This is about the Winston-Salem C&D Landfill

This note and accompanying segments of Drawing C-6 from the Winston-Salem C&D Landfill "Construction Plan Application" are sent as initial response to your comments and our telephone conversation of September 20, 1995.

Subject: Site Plan Application  
Proposed Winston-Salem Construction and Demolition Landfill  
Forsyth County

RE: Proposed Winston-Salem Construction and Demolition Landfill

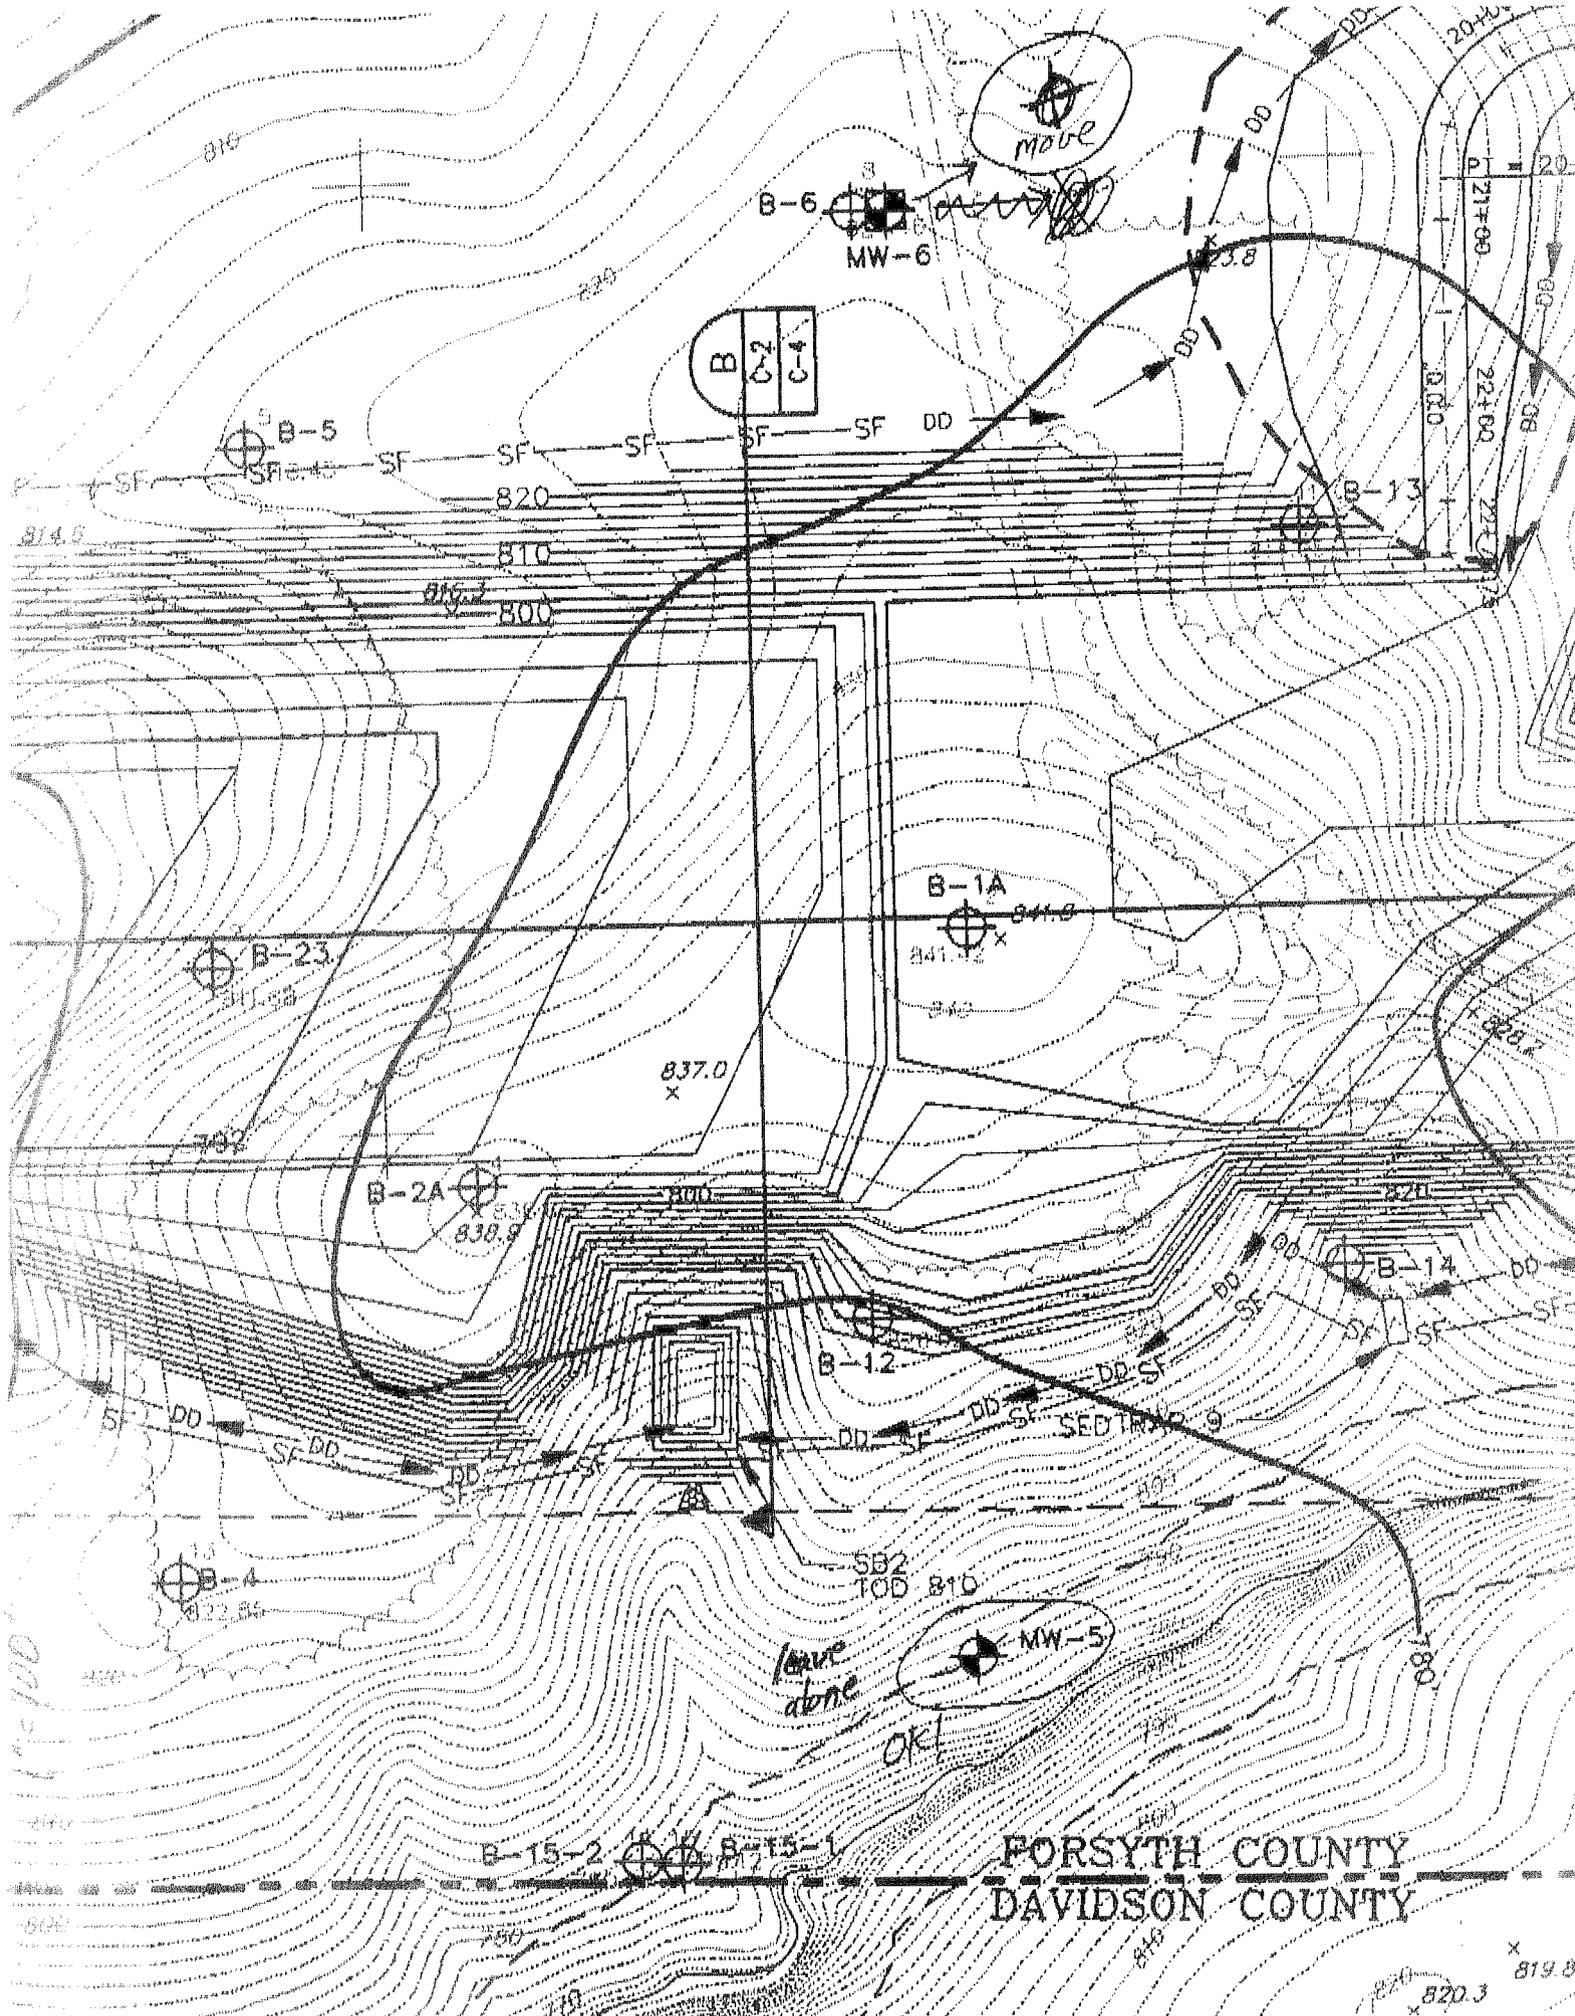
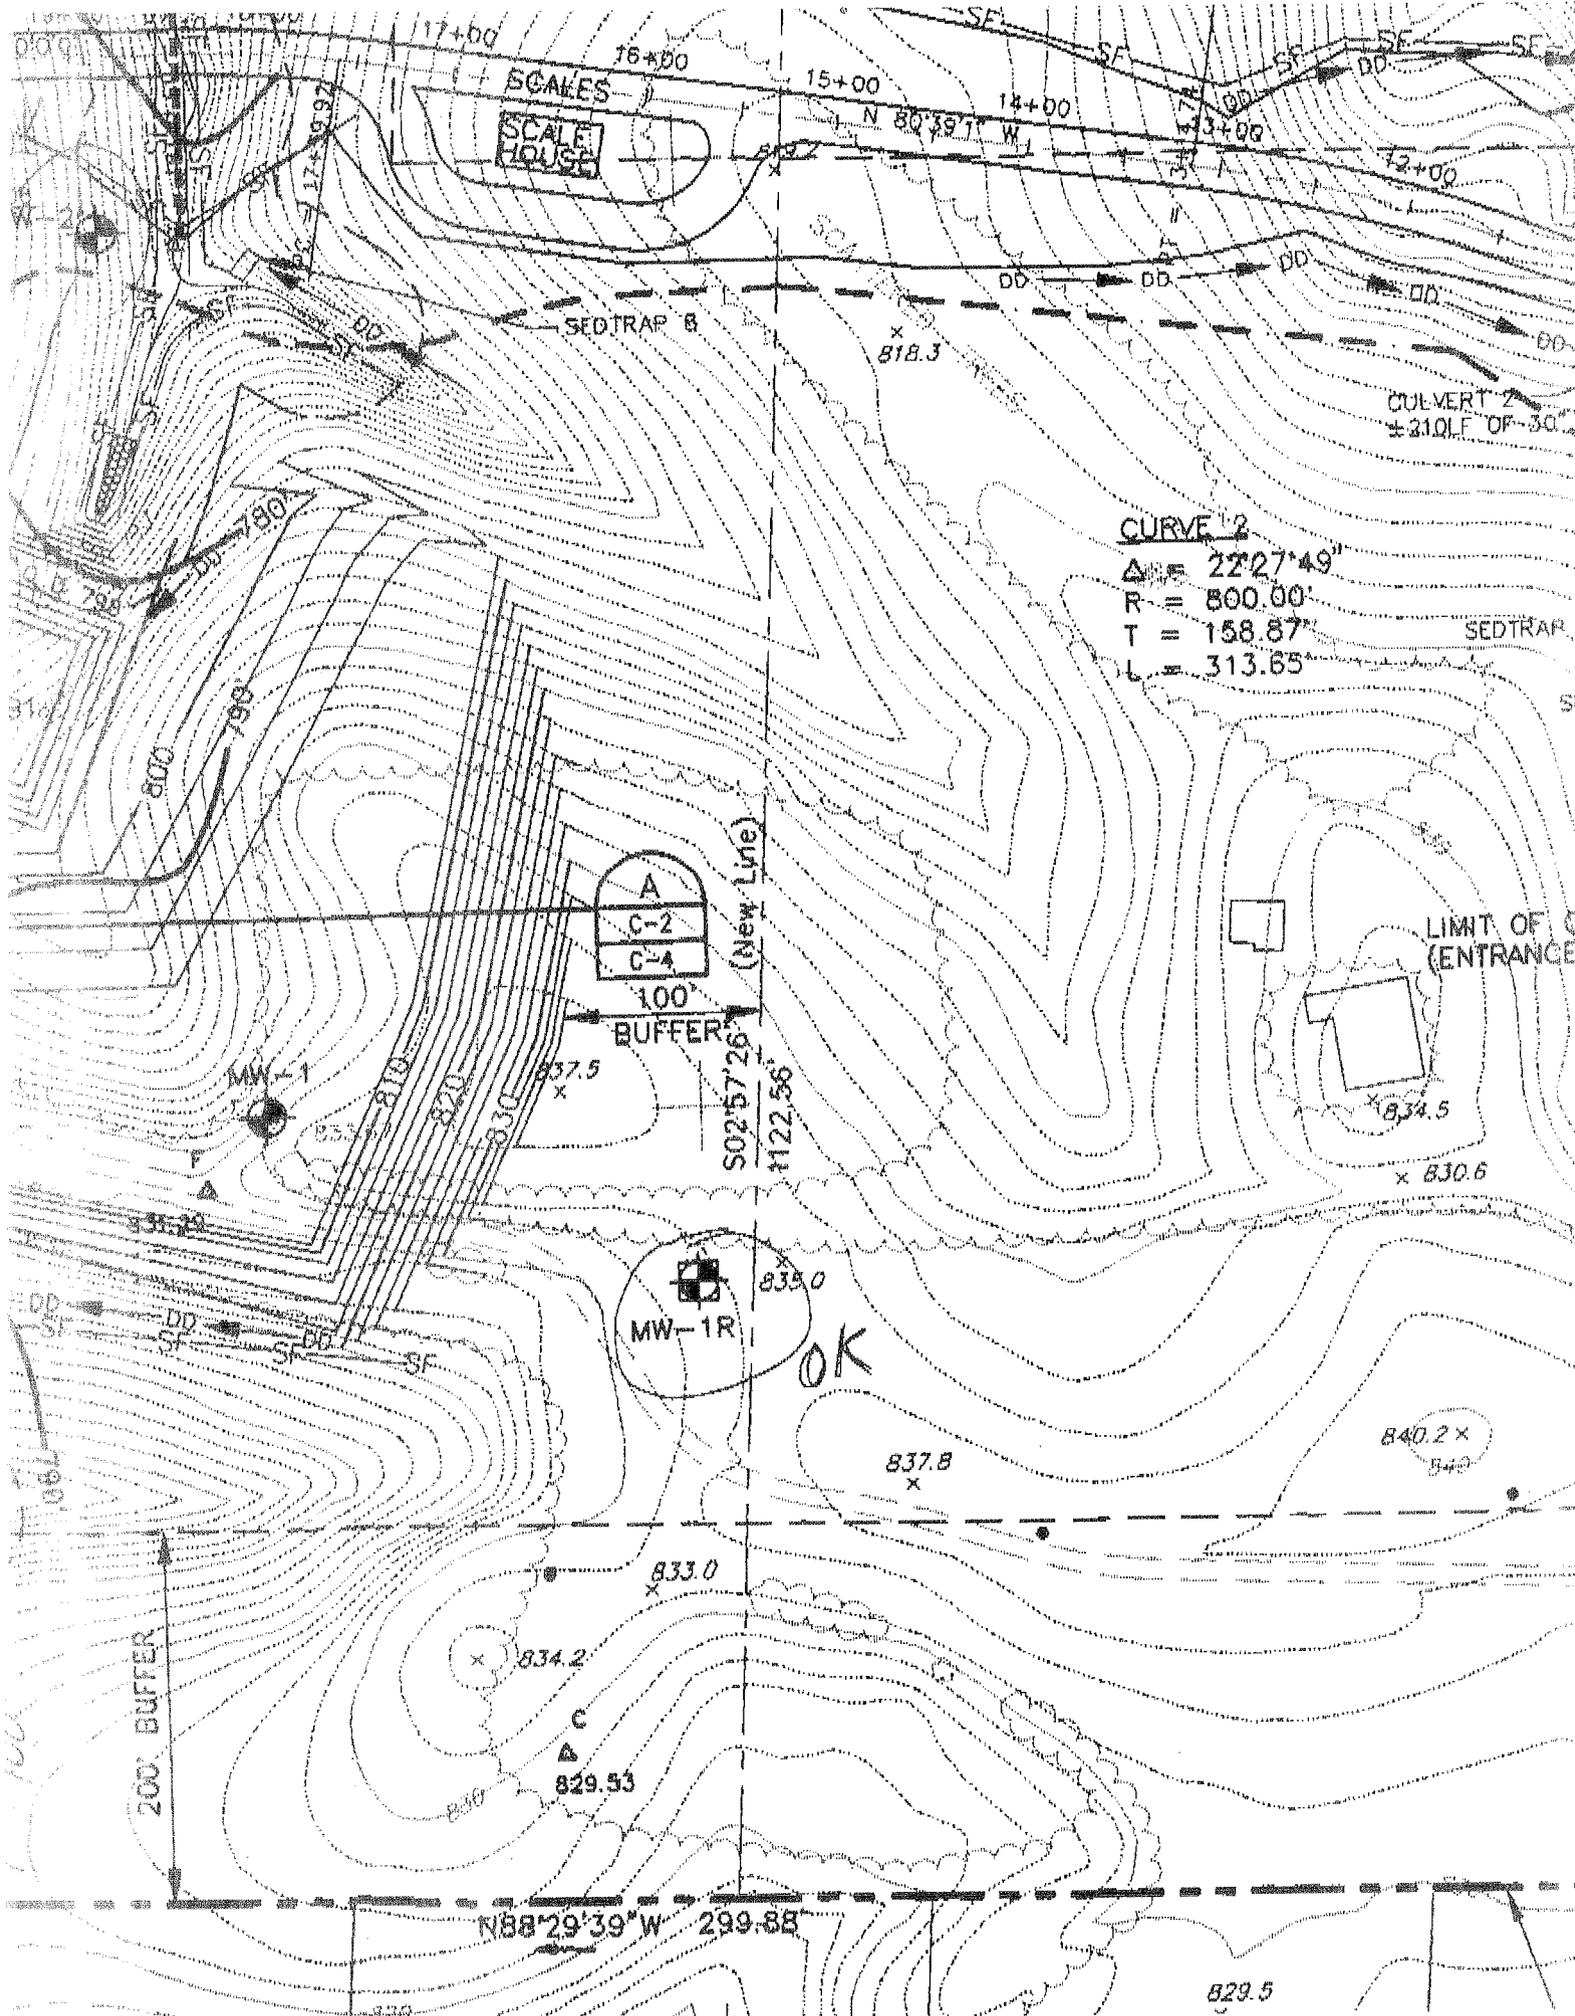
- ◆ Install an additional well to the northwest of the initial waste area. This new well is shown as "new well" on the accompanying maps. We agree that this well could form an important component of the ground-water monitoring system, particularly in light of the drinking water wells at residences located just to the west.

- ◆ In the "Construction Plan Application," we had proposed to install two new wells, MW-1R and MW-4R to replace MW-1 and MW-4, which are located in the footprint of the waste cell. You felt that the proposed location of MW-4R would be better if placed near the surface drainage swales as shown on the accompanying map and that is fine with us. The proposed location for well MW-1R is fine as is.

- ◆ In the "Construction Plan Application," we had proposed to install a new well, MW-6, along the north edge of the current fill area. You commented that you would like to see this new well placed near the drainage swale as shown on the accompanying map.

In our conversation, you also requested that existing well MW-5 be abandoned and a new well be placed approximately 100 feet west, again near a drainage swale. I strongly feel that this is an unnecessary burden for our client and that the existing well is already positioned to provide the required ground-water monitoring in this area. Allow me to elaborate.

In our conversation, you mentioned that both you and Bobby Lutfy apparently feel it is important to place wells completed in saprolite near drainage features because you believe that these features are an expression of fracture patterns or other linear features inherited from the precursor bedrock. I understand this general rationale but disagree on the details. In my experience, fractures in Piedmont bedrock typically occur as joints in the rock which are developed on a regional scale. The most important point here is that these joints are closely spaced - usually at a scale of inches to a few feet. Thus, inherited "fractures" in saprolite would also be at this scale. When we do rose diagrams which may statistically show the overall fracture orientations in an area's bedrock, we always find many linear drainage features that are oriented at all directions and do not follow the regional "fracture" pattern. To relate an individual drainage feature to these "fractures" in saprolite is problematic at best. In addition, with closely spaced fractures the norm

in Piedmont rocks, a ground-water monitoring well will normally intercept these relict structures in saprolite, no matter its location.

The second point I want to make is that the dominant flow in saprolite is through the intergranular pore system. Yes, I agree that there can be "short circuits" from quartz veins and possibly from inherited fractures, but I believe that the bulk of flow takes place in the intergranular pore system. Obviously, well MW-5 is monitoring that pore system.

Third, let's consider the type of monitoring taking place at a landfill. In landfill monitoring, we are not looking at a point source but rather at a large area. Potential contamination from a landfill can enter the water table at many places. One does not expect narrow fingers of contamination to slide by the monitoring system.

Which leads me to my final point. By its fine-grained, poorly sorted nature, the Piedmont saprolite ground-water system has large dispersivity. We take advantage of this characteristic in having fairly large spacings between monitoring wells.

Taking all of these facts together, I see no reason to spend some more thousands of dollars of our client's money to shift a monitoring well to a location that, frankly, is in no objective way any better suited than its current location. Let's leave it where it is.
